North Hertfordshire District Council

Building Conservation comments

File Ref: 25/00018/FP

Subject: Change of use from a funeral parlour - E(c)(ii), to 4 number dwellinghouses - C3(a) and associated single storey extensions. Removal of existing entrance portal and installation of new privacy gates following demolition of existing car port roof structures.

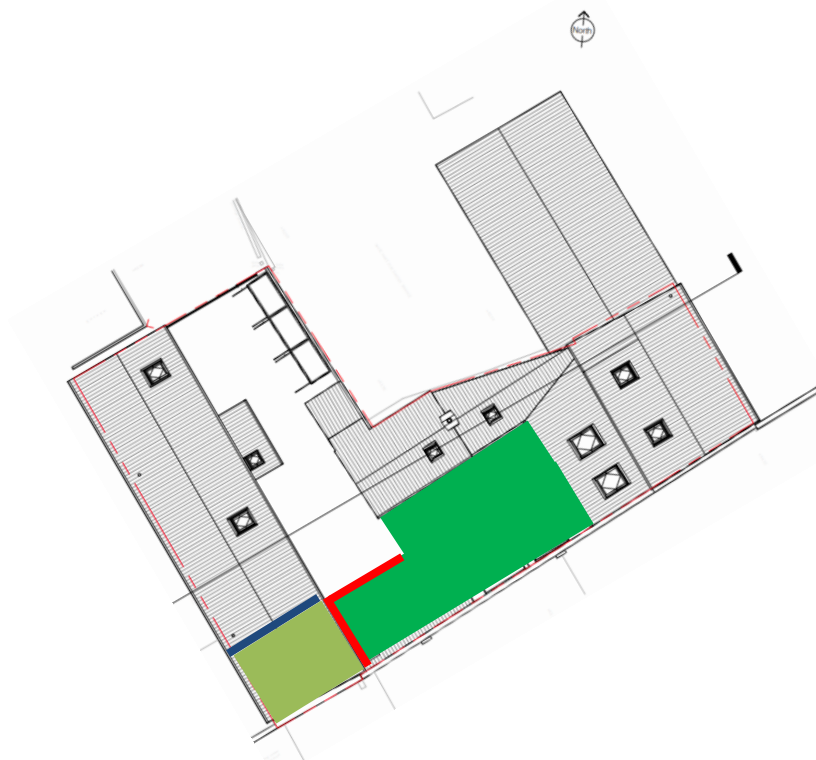
- 4.3 Although not a conservation consideration, I note that Units 1 & 2 achieve the minimum nationally described space standard whilst Units 3 & 4 exceed this standard (see below).

- Unit 1 – 37m²
– 1b 1p
 - Unit 2 – 39m²
– 1b 1p
 - Unit 3 – 65m²
– 1b 2p
 - Unit 4 – 100m²
– 2b 3p
- 4.4 Noting that Units 1 and 2 are afforded the minimum standard, I have looked at the current configuration and whether there is an opportunity not only to increase the size of these units but to also see if other positive measures can be realised.

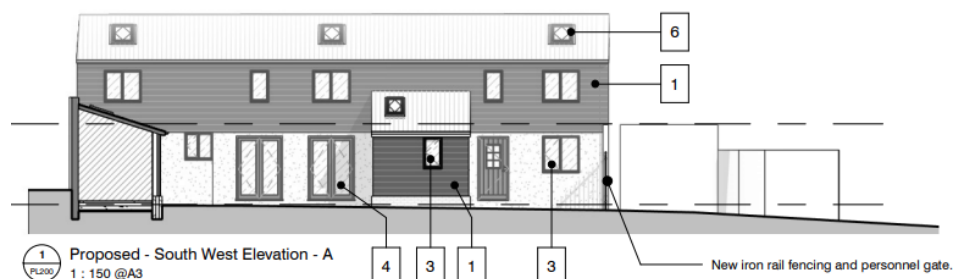
- 4.5 What do I mean by this? Well, there may be an opportunity here to create a slightly better arrangement whereby two units would have private amenity space, including a space for Unit 4 which would be commensurate with a 2b 3p unit. What I have looked at is whether it would be possible to part demolish the elongated building on the south-west boundary. If the building was limited to the blue line in the image below then a small courtyard area could be achieved for ground floor Unit 1 which would also benefit from a larger lounge area with access onto this courtyard. Unit 2 would be increased by the same amount affording this unit either more living room space or a larger bedroom or a bit of both. A wall could perhaps be erected where the red lines are shown with a gated front garden access to Unit 4 (which would become Unit 3). This would also reduce the amount of structures on the south-east boundary, providing a better aspect out from the living room for the larger unit.

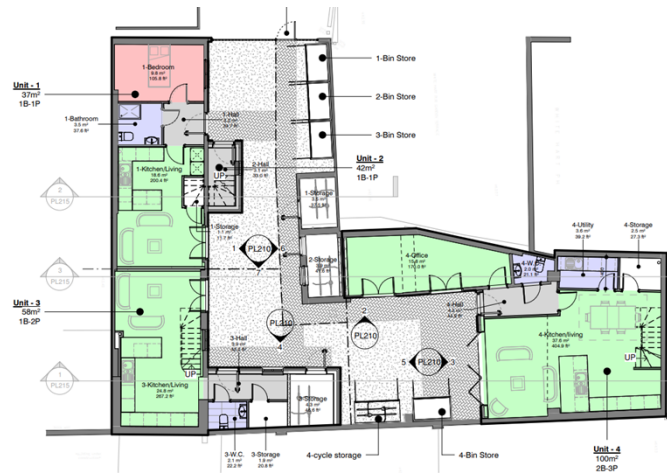
- 4.6 A further benefit of the above approach is that the two pairs of glazed doors to proposed Units 1 and 3 on Elevation A, would not be necessary and could perhaps revert to windows on the basis that French doors could be provided in what would be the new south gable end for Unit 1.
